FINAL FINDINGS AND DECISION BY THE DESIGN COMMISSION RENDERED ON July 23, 2020

CASE FILE NUMBER: LU 19-264010 DZ
[PC # 19-169687]
Water Tower: Building and Site Alterations

Type III Design Review for proposed building and site alterations including: Renovation of existing building storefronts along all facades, demolition of existing east first floor façade (facing SW Macadam Ave) to be rebuilt in line with existing second and third floor east elevation facade; new sign package; redesign and reconfiguration of existing northeast main entry plaza, north parking area, and southwest courtyard area. No Modifications or Adjustments are requested at this time.

A.5 | SEA

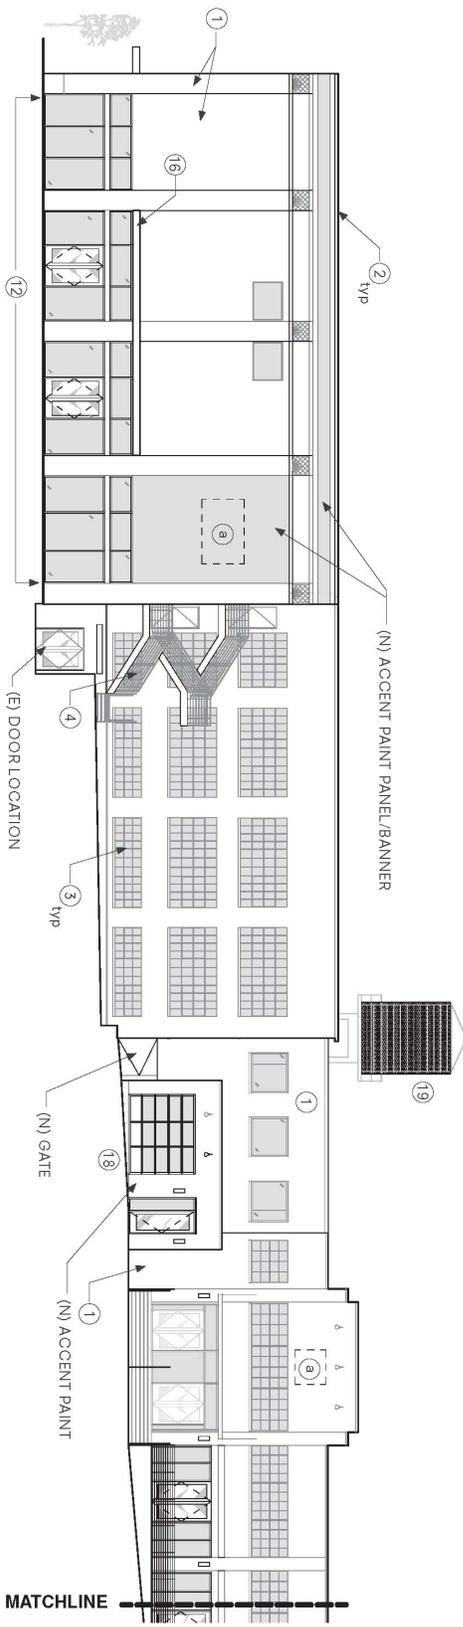
Because drawings are not consistent regarding the location of steel canopies along the east elevation of the site (i.e. they appear on sheet A.5 but not on sheets A.4 or A.9 and are not called out on sheet A.7), staff has added a condition of approval that canopies are to be included between the six bays on the east elevation, above the proposed new storefront systems, consistent in location on the building with the canopies shown on the north elevation (at the north-east corner) of the building. To provide sufficient weather protection and pedestrian comfort, canopies along the east elevation are to extend 4’ from the building face.
